Access Compliance Report Public Rights-of-Way (Curb Ramps)

Main Street: CLYDESDALE_DR Cross Street: ABYSSINIAN_WAY Location: E

ADA ID: RPRK211110132006 Ramp Type: Type 4 - Parallel Initial Pass/Fail: Fail Overall Compliance: No Severity Score: 32

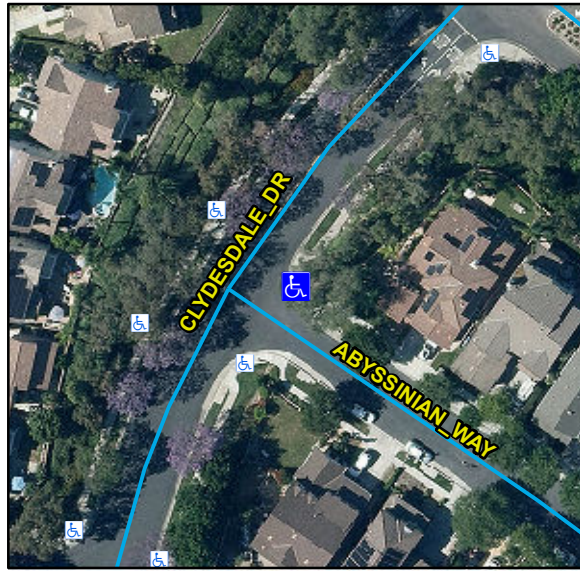
Compliance	Description	Data	Compliance	Description	Data
N/A	Ramp Length LT (in)	125	N/A	Ramp Length RT (in)	139
Yes	Ramp Width LT (in)	54	Yes	Ramp Width RT (in)	54
Yes	Ramp Run Slope LT (%)	7.8	No	Ramp Run Slope RT (%)	19.1
No	Ramp Cross Slope LT (%)	3.3	Yes	Ramp Cross Slope RT (%)	0.7
N/A	Landing Present	N/A	N/A	DWS Provided	N/A
N/A	Landing Length (in)	N/A	N/A	DWS Contrast	N/A
N/A	Landing Width (in)	N/A	N/A	DWS Length (in)	N/A
N/A	Landing Run Slope (%)	N/A	N/A	DWS Full Width	N/A
N/A	Landing Cross Slope (%)	N/A		DWS Offset Type	N/A
N/A	Landing Movement Obstructed?	N/A	N/A	DWS Offset Left (in)	N/A
	Landing Movement Type	N/A	N/A	DWS Offset Right (in)	N/A
N/A	Landing Shared	N/A			
N/A	Clear Space	Yes			
N/A	Clear Space To Crosswalk (in)	N/A			
N/A	Marked Crosswalk 1	No	N/A	Marked Crosswalk 2	No
	Crossing 1 Direction	NW		Crossing 2 Direction	SW
	Marked Crosswalk 1 Width (in)	N/A		Marked Crosswalk 2 Width (in)	N/A

Remove & Replace Curb Ramp With Two New Directional Ramps or Equivalent.
